RS-10-102

LaSalle County Station, Units 1 and 2  
Facility Operating License Nos. NPF-11 and NPF-18  
NRC Docket Nos. 50-373 and 50-374

Subject: Additional Information Supporting License Amendment Request Regarding the Use of Neutron Absorbing Inserts in Unit 2 Spent Fuel Pool Storage Racks

**ATTACHMENT 1**  
**Response to Request for Additional Information**

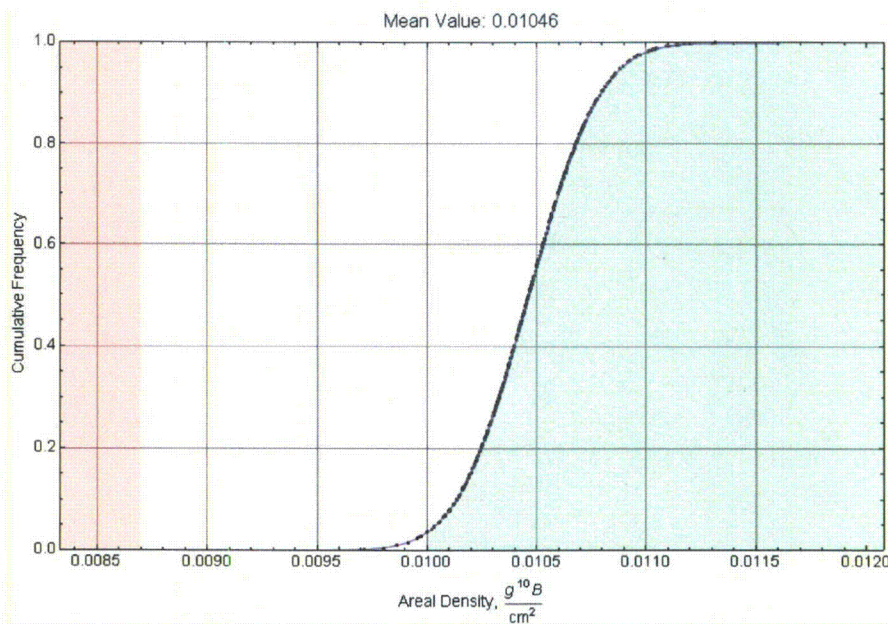
Text from Attachment 1, Section 3.3.2, "Areal Density of Boron," notes that lower limit for the areal density of boron (B) in the Rio Tinto Alcan composite is 0.0087 g Boron-10 per centimeter squared ( $^{10}\text{B}/\text{cm}^2$ ). What is the uncertainty associated with the measurements used to confirm that the "manufacturing insert quality assurance testing lower limit for areal density" is met? Describe how the areal density assumed in the analysis accounts for the measurement uncertainty.

The uncertainty associated with the neutron attenuation testing varies between 0.0003 and 0.0009  $\text{g } ^{10}\text{B}/\text{cm}^2$ . This measurement uncertainty is taken into account, at a 95% confidence level, when determining the acceptability of a given coupon test result. Individual tested coupons must exceed the 0.0087  $\text{g } ^{10}\text{B}/\text{cm}^2$  limit with this uncertainty subtracted from the measured value. Additionally, an analysis is performed on the coupon population's areal density to ensure that the 95/95 limit of the production batch exceeds the minimum specified areal density value of 0.0087  $\text{g } ^{10}\text{B}/\text{cm}^2$ . Production batches encompass all inserts made from the same stock of raw material. The following plot shows the LaSalle County Station (LSCS) insert test coupons measured to date imposed upon a cumulative normal distribution function having the same mean (0.01046  $\text{g } ^{10}\text{B}/\text{cm}^2$ ) and standard deviation (0.00026  $\text{g } ^{10}\text{B}/\text{cm}^2$ ) as the population of test coupons. The red region to the left represents the region of the plot that falls below the minimum certified value. The population reflected in the plot consists of 394 samples and has a minimum value of 0.0097  $\text{g } ^{10}\text{B}/\text{cm}^2$  and an uncertainty on the mean of 0.000013  $\text{g } ^{10}\text{B}/\text{cm}^2$ . With 95% confidence, 95% of the population of measurements falls within the green area of the plot with a minimum 95/95 value of 0.0100  $\text{g } ^{10}\text{B}/\text{cm}^2$ . It can be seen that the population is well in excess of the minimum certified value for the LSCS inserts. This methodology is to be applied to all inserts produced for LSCS to insure appropriate margin to criticality.
